Consultation on Prince of Wales Road/ Kentish Town Road and Anglers Lane

This response to Camden Council's proposals for Prince of Wales Road (PoW)/ Kentish Town Road (KTR) and Anglers Lane is from Camden Cycling Campaign, the local borough group of London Cycling Campaign. We represent the interests of cyclists living or working in Camden and aim to expand the opportunities for all to cycle safely in the borough. We have discussed this consultation by email and online (using Cyclescape) as well as at our members' meeting on 17th December 2018.

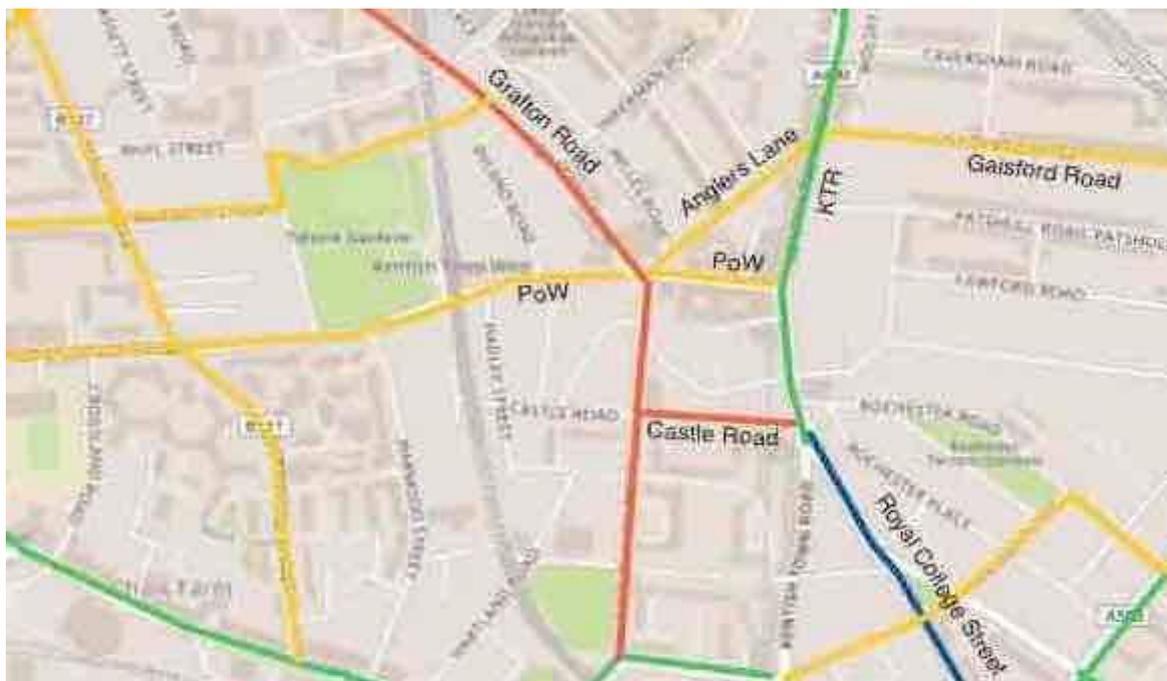
With a more radical approach, pedestrians could be provided with an 'all green' signal stage and straight-across crossings. This would mean that:

- the crossing over the north arm of the junction could remain in place and there would be no need to move the crossing outside No 225;
- without an island on PoW, a separated cycle lane could be provided together with early release or, better still, a separate signal stage.

We gather from the consultation document that TfL modelling is likely to reject such an idea due to a consideration of adding more congestion to KTR which is part of the SRN. However we would like to emphasise that the above is our preferred solution as it would provide many more benefits for people who walk and cycle.
